SUBMITTAL OF HANFORD FACILITY RESOURCE CONSERVATION AND RECOVERY ACT (RCRA) PERMIT MODIFICATION NOTIFICATION FORM 24590-LAW-PCN-ENV-07-002

Modification Notification Form 24590-LAW-PCN-ENV-07-002 updates the Low-Activity Waste (LAW) Vittrification Building Piping and Instrumentation Diagrams for the LAW Primary Offgas Process System Concentrate Receipt Vessel LCP-VSL-00001, and LAW Primary Offgas Process System Concentrate Receipt Vessel LCP-VSL-00002, in Appendix 9.2 of the Reference.

Hanford Facility RCRA Permit Modification Notification
Form 24590-LAW-PCN-ENV-07-002

LAW Vitrification Facility - Piping and Instrumentation Diagram P&ID 24590-LAW-M6-LCP-P0001 (Rev. 3)

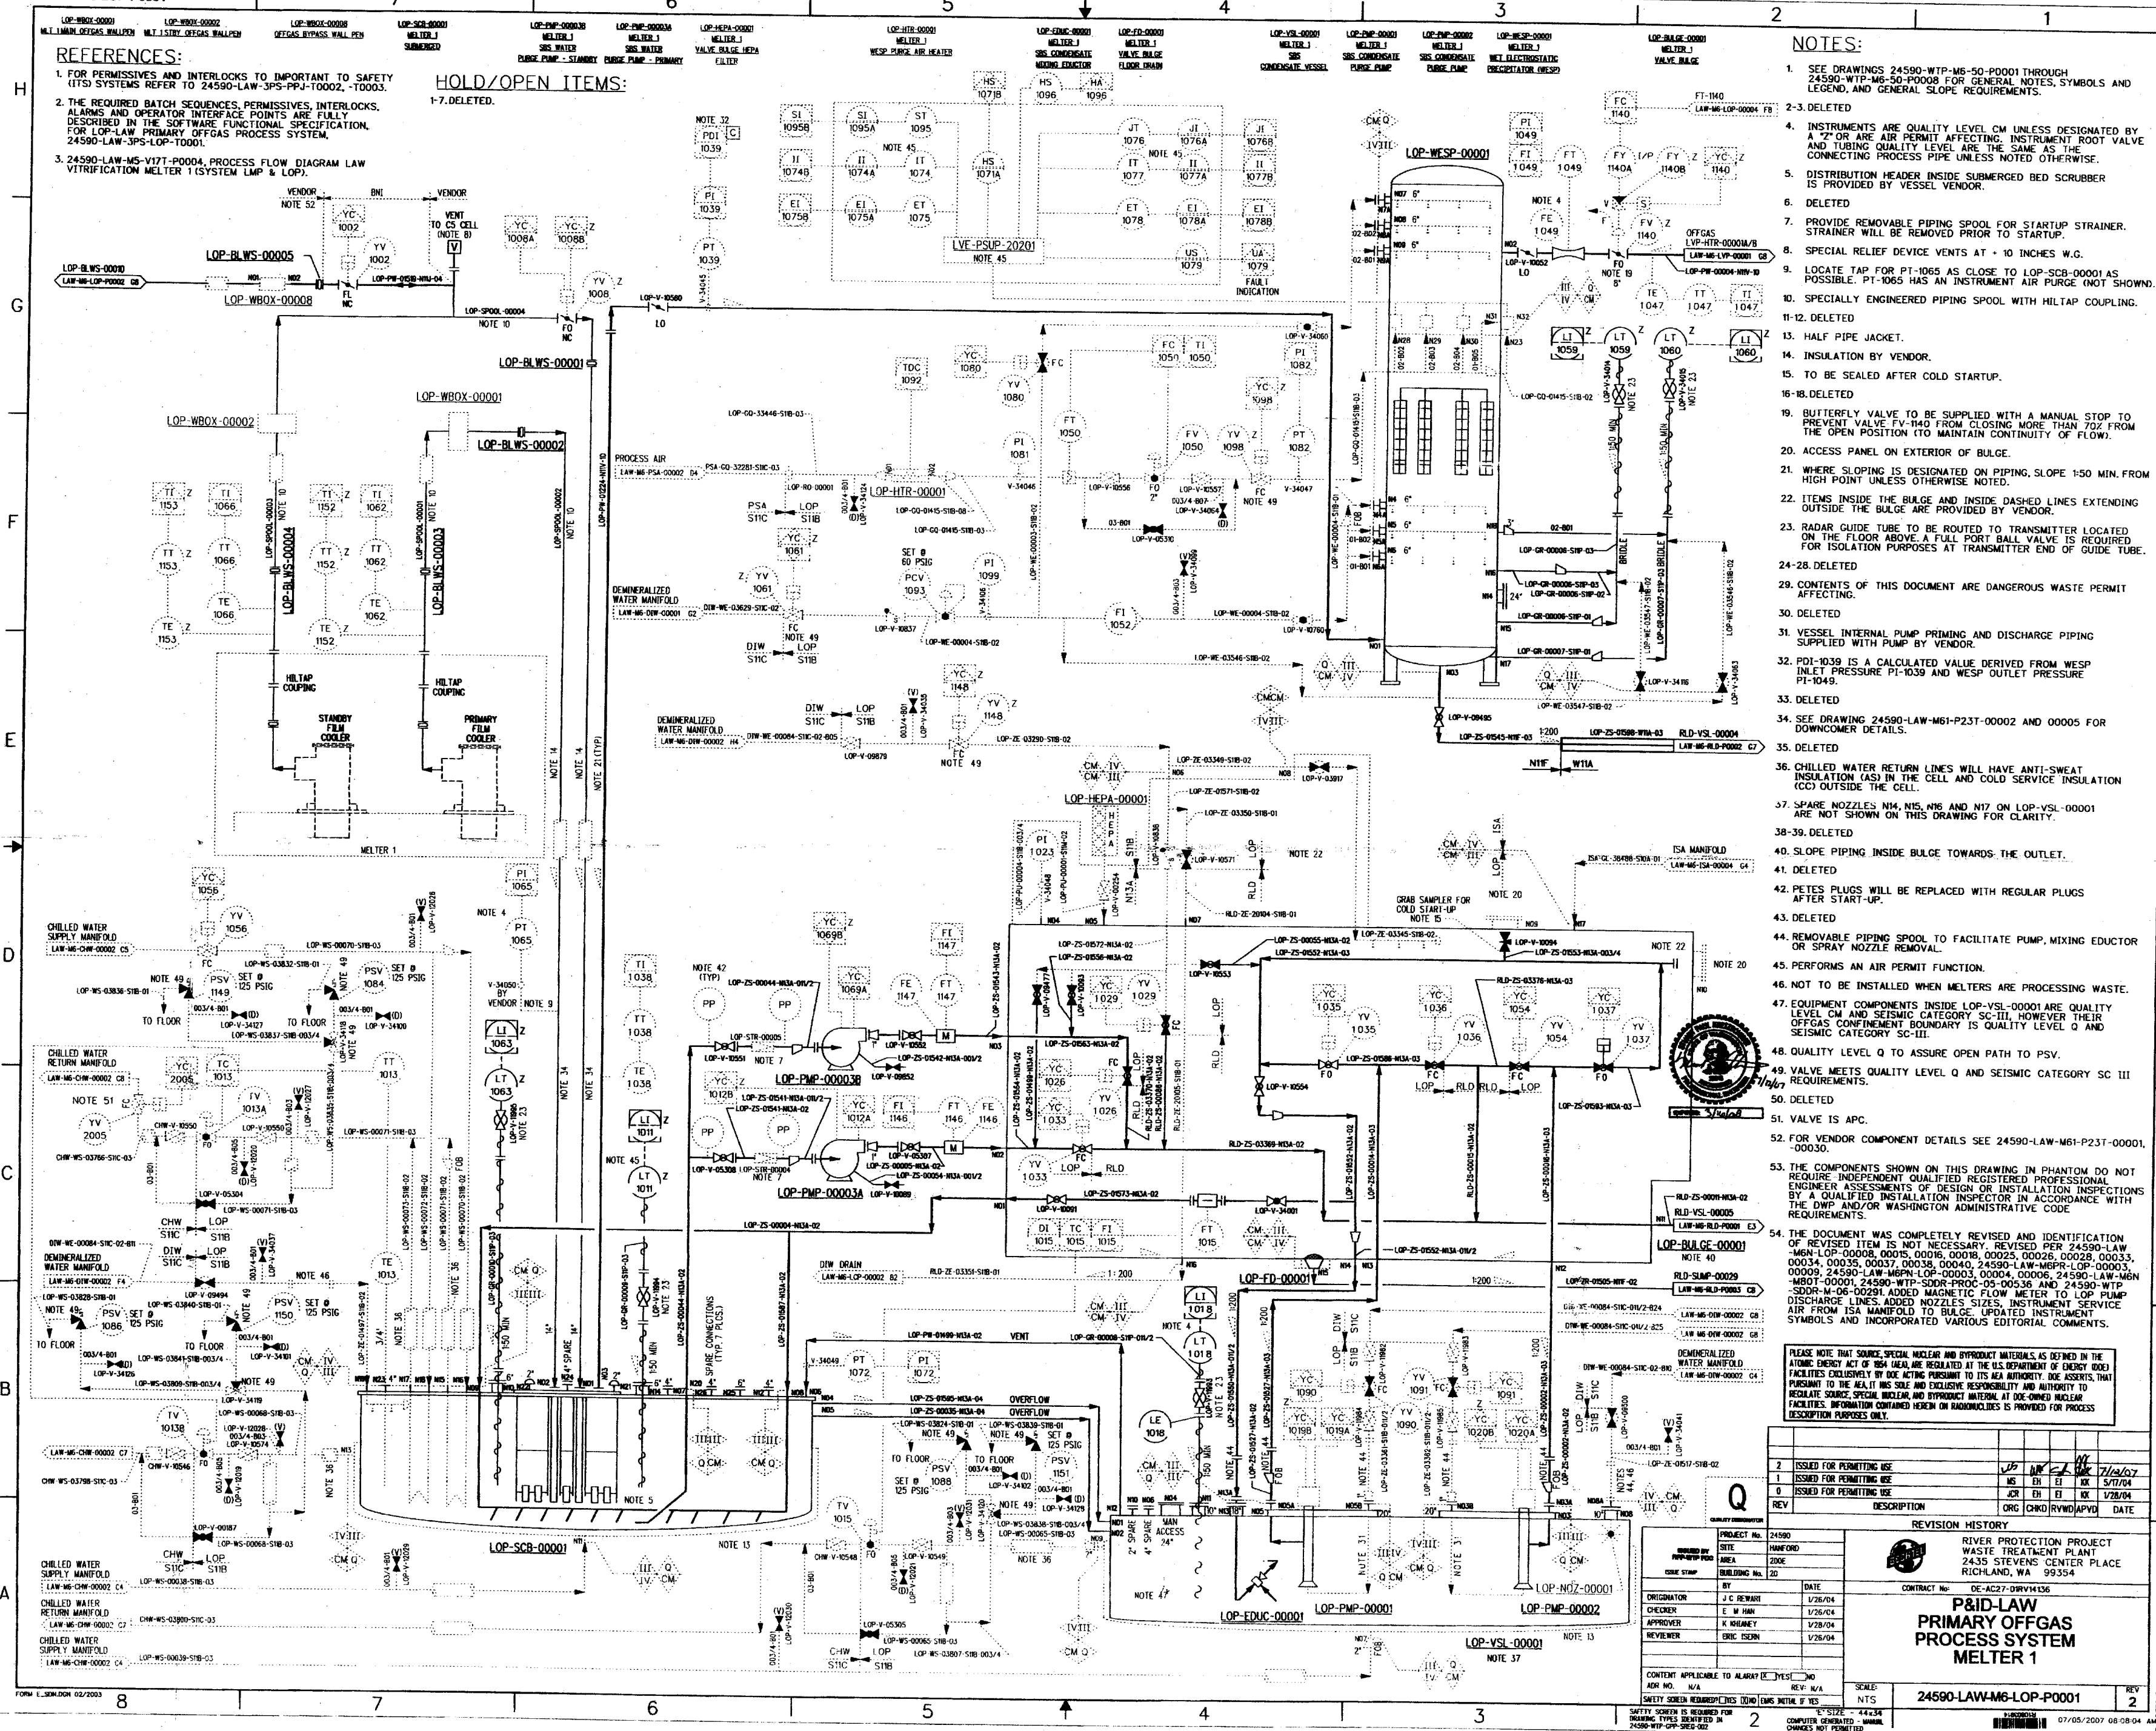
The DCNs associated with changes to P&ID 24590-LAW-M6-LCP-P0001 are provided in drawing Note 43.

- Revised physical layout of LCP-VSL-00005
- Added overflow line from LFP-VSL-00002
- Changed Quality Designator from CM to Q
- Added and/or revised notes 1, 28 through 33 and Note 40 and their callouts such as symbols and legends, slopes, valve locations, and system designators
- Added slope notation to numerous lines
- Added magnetic flow meter and associated instrumentation to pump discharge lines
- Corrected off-sheet coordinates
- Added ISA lines to bulges
- Added seismic category and quality flag designators
- Added nozzle size to vessel nozzles
- Incorporated various editorial comments
